Rezoning Transportation Analysis

Petition Number: #2022-091

| Date | Description |
|----------|-------------------|
| 11-28-22 | First Review (IW) |

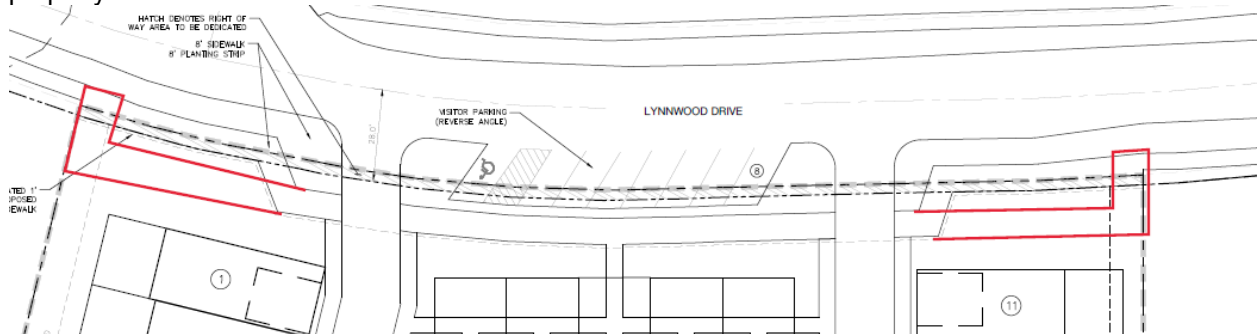
1. **Curbline:** The proposed zoning district has a setback measured from back of the existing or proposed future curbline.
 - a. **Lynnwood Drive:** The future location of curb and gutter should follow the CLDSM Local Residential Medium Street which is measured at 13-feet from the centerline of the roadway to the BOC.

Label and dimension the curb and gutter from the centerline for each road on the site plan.
